PUBLIC UTILITIES COMMISSION

PG&E AL 6014-E-A
SCE AL 4359-E-A
SDG&E AL 3654-E-A

Subject: Staff Disposition of PG&E AL 6014-E-A, SCE AL 4359-E-A, and SDG&E AL 3654-E-A – Supplemental Advice Letters Modifying Electric Rule 21 Pursuant to Decision 20-09-035 for Working Group 2 and 3 (due 60 Days from Issuance)

Attachment 1

Sheet 141

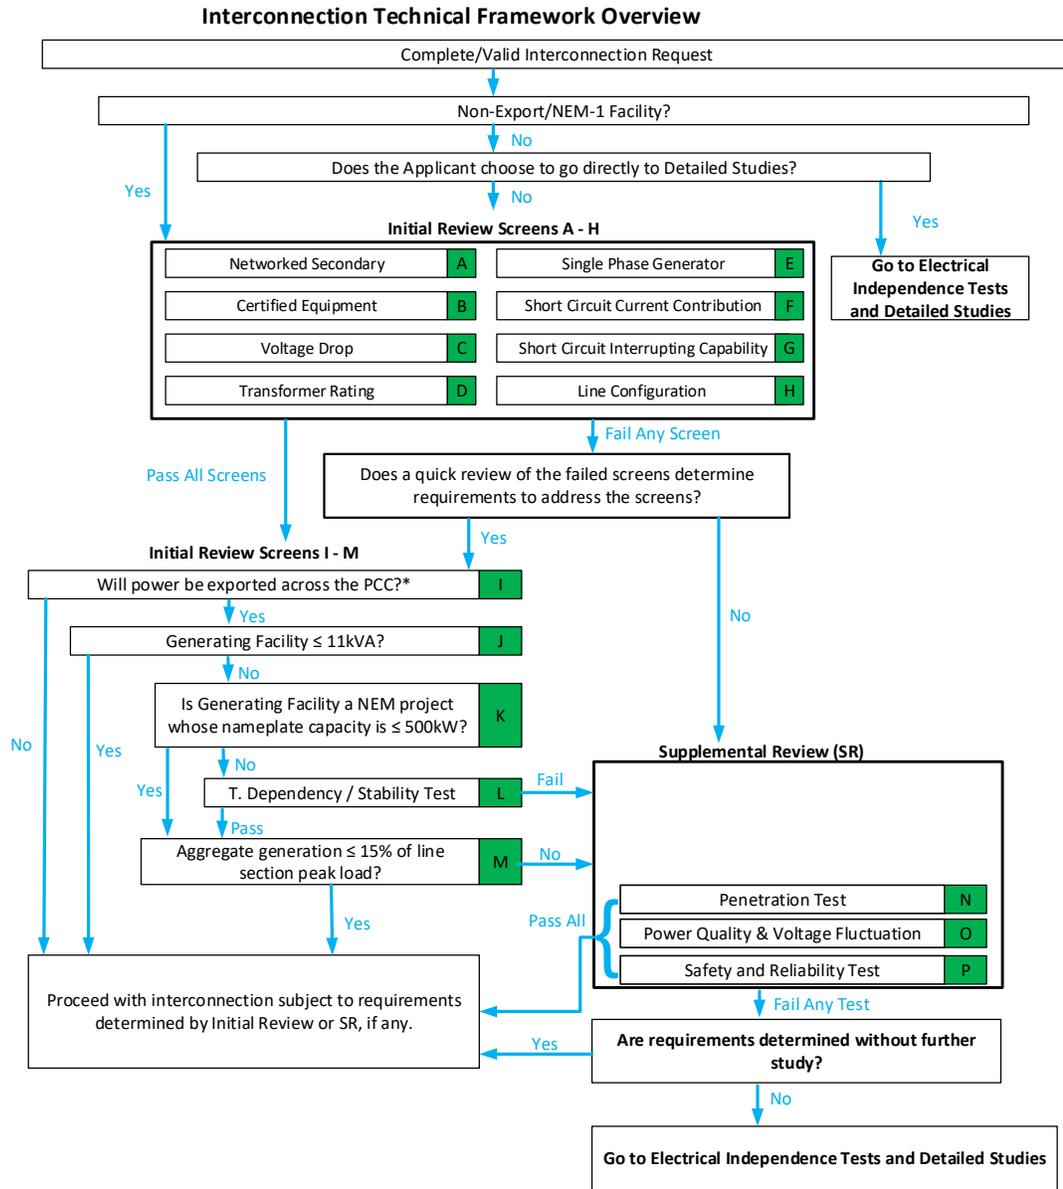
The Screen flow chart is modified given the new requirements. The current process is shown below (the red circled part is changing) (original sheet 141):

Disposition: In the Supplemental ALs, the IOUs have adopted IREC's recommended language for section E.2.b.i and have added the following sentence at the end of IREC's proposed language: "Applicants are encouraged to review the Integration Capacity Analysis for information relevant to their project."²⁹ Staff finds the addition of this extra sentence does not alter IREC's proposed language; instead, it integrates the Working Group Two's caveat for the customer to reference the ICA—as SCE notes, this was listed as a caveat in the Working Group Two Final Report. The IOUs have also adopted IREC's recommended flowchart. Therefore, Staff finds IREC's protested issue is resolved.
